**ALBERTA TRANSPORTATION SPRINGBANK OFF-STREAM RESERVOIR PROJECT
RESPONSE TO NRCB AND AEP SUPPLEMENTAL INFORMATION REQUEST 1, JULY 28, 2018**

Natural Resources Conservation Board
May 2019

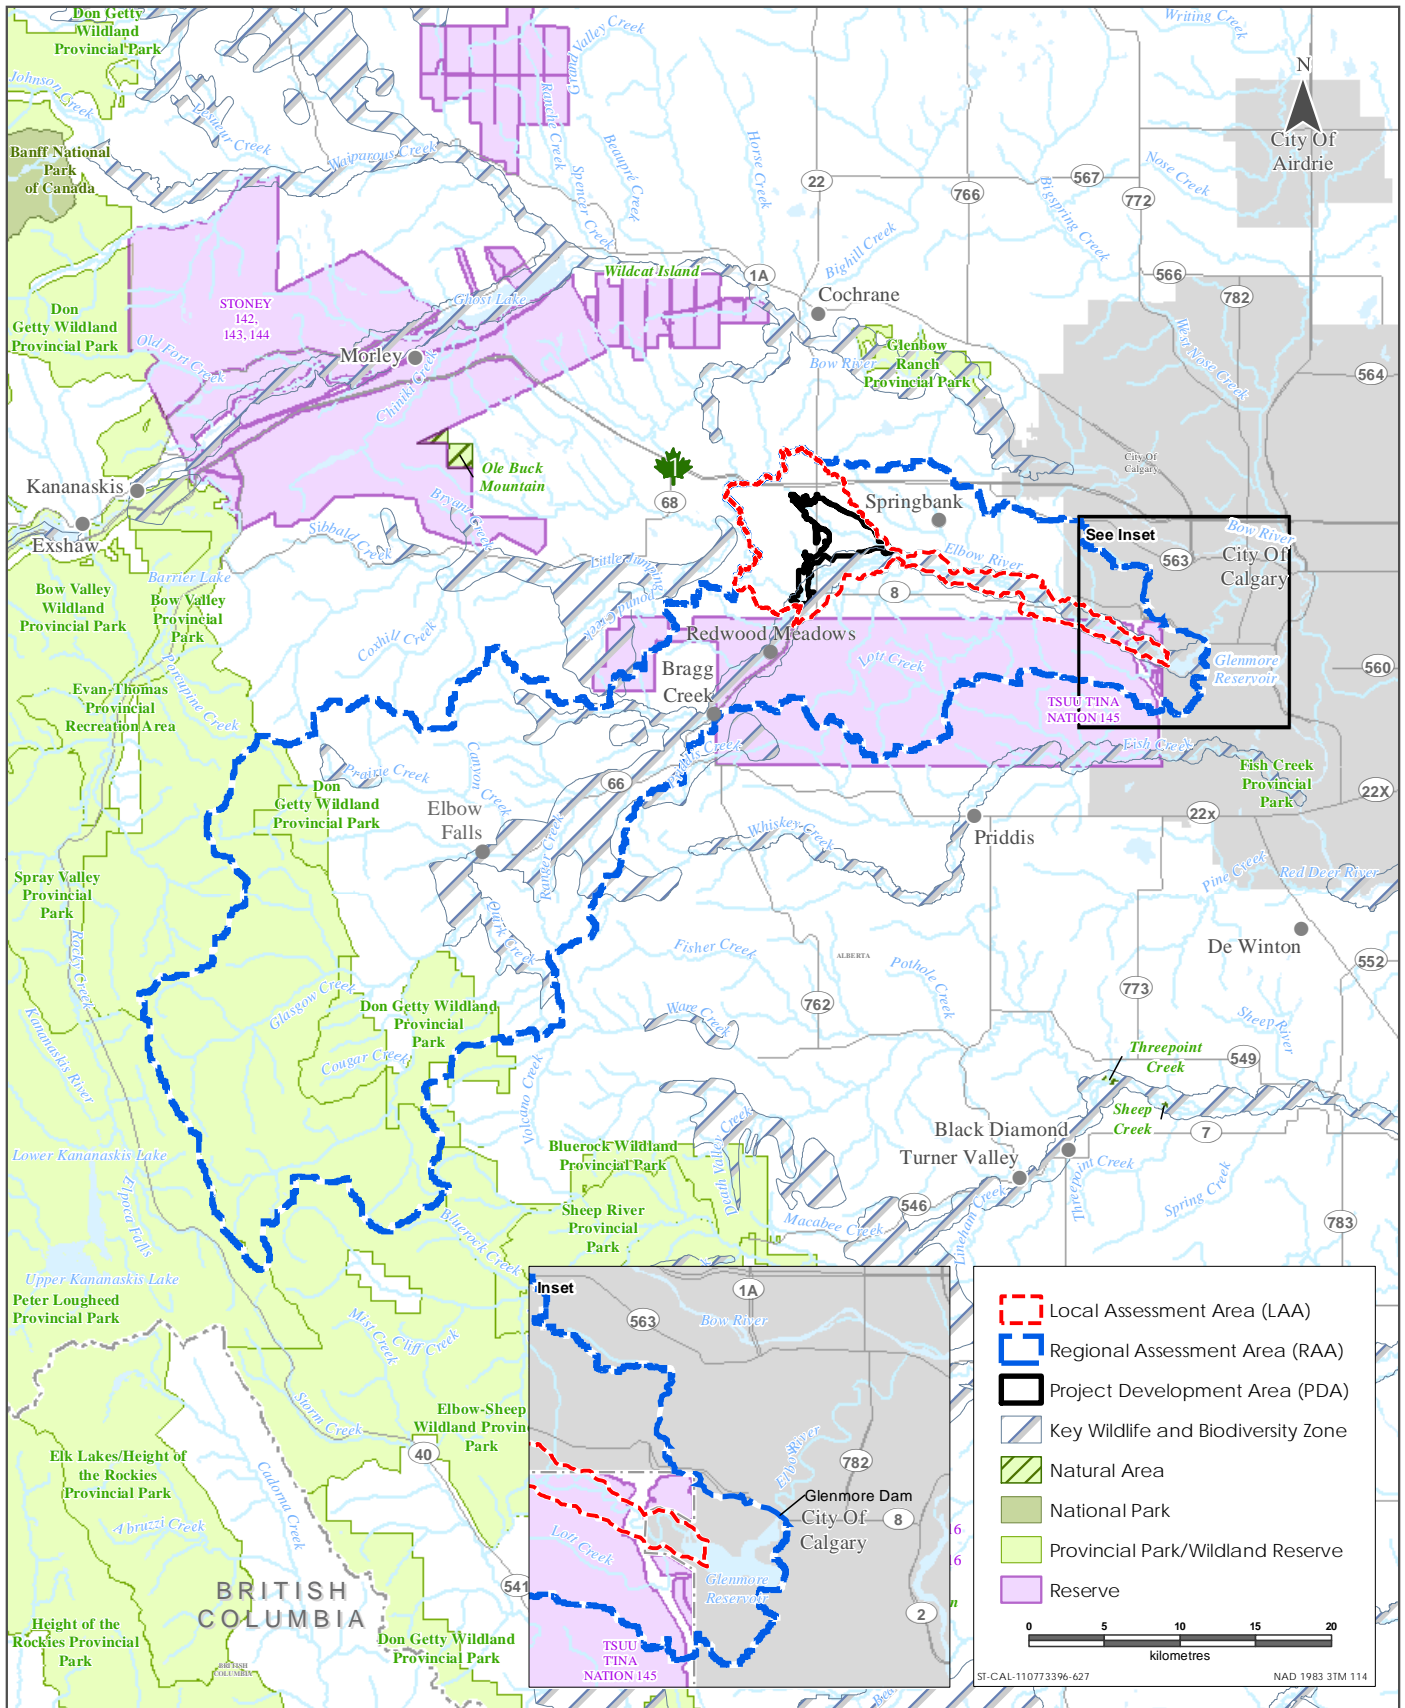
Alberta Transportation states that the LAA included the PDA and the Elbow River from Redwood Meadows to the inlet of Glenmore Reservoir (Volume 3A 6.1.4.1), that the LAA extends from the diversion structure...(Appendix J, 2.1). In Figure 6-1 (which is used again in various sections) it appears it may start below Redwood Meadows (i.e., inlet structure) and that the LAA may include the Glenmore Reservoir.

Alberta Transportation states that the RAA is the Elbow River watershed from headwaters to Glenmore Dam (Volume 3A, 6.1.4.1), that the RAA is the Elbow River watershed, including Glenmore Reservoir (Appendix J, 2.1), and Figure 6-1 appears to include the entire watershed, including the Glenmore Reservoir and upstream and downstream of the Glenmore Reservoir.

Volume 3A, Section 6, Figure 6-1 is incorrect; see Figure IR54-1 in the response to IR54 for the correct boundary of the LAA for both the hydrology and water quality LAA. The LAA includes Elbow River to the inlet of Glenmore Reservoir but does not include Glenmore Reservoir.

By diverting flow greater than 160 m³/s, the hydrology of Elbow River between the Project site and Glenmore Dam is jointly managed by AEP and the City of Calgary. The control of hydrology downstream of Glenmore Dam is under the sole control of the City of Calgary. Therefore, the hydrology RAA for the Project does not extend downstream of Glenmore Dam. Volume 3A, Figure 6-1 is incorrect for the boundary of the hydrology RAA. Figure IR54-1 shows the correct boundary.

Volume 3A, Figure 7-1 shows an incorrect boundary for the surface water quality RAA. Figure IR54-1 is also a correction to Figure 7-1.
